ADDENDUM #1

C-4016, INC. 3, DEMO AND ABATEMENT OF PHYSICAL SCIENCE AND BIOLOGICAL SCIENCE BUILDINGS AND OTHER STRUCTURES

REQUEST FOR INFORMATION #1

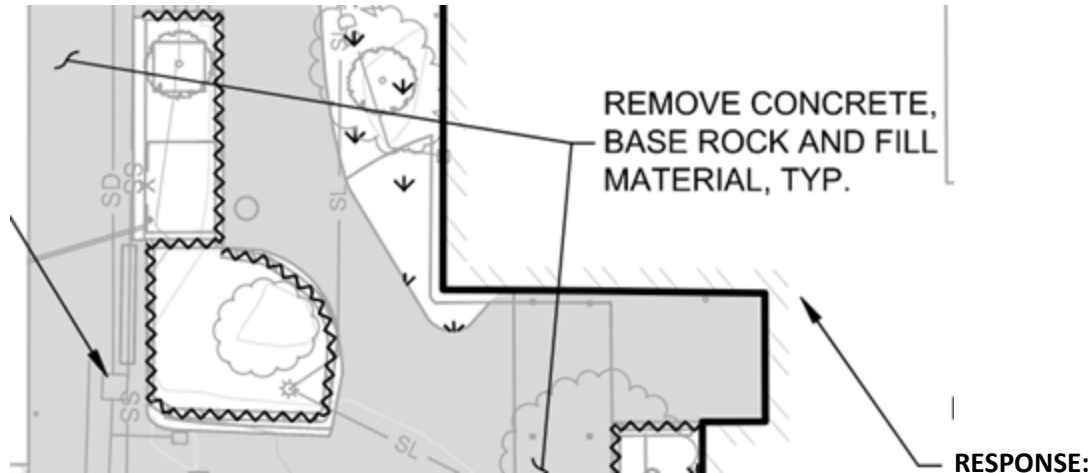
Sheet C2.00; Demolition Note #18. This note is incomplete. Please provide a complete note.

The complete note is as follows: "18. THE CONTRACTOR WILL BE REQUIRED TO PROTECT THE FIRE ACCESS ROAD IF THEY USE IT TO ACCESS THE SITE. CONTRACTOR WILL BE LIABLE FOR ANY DAMAGE THEY CAUSE TO THE FIRE ACCESS ROAD."
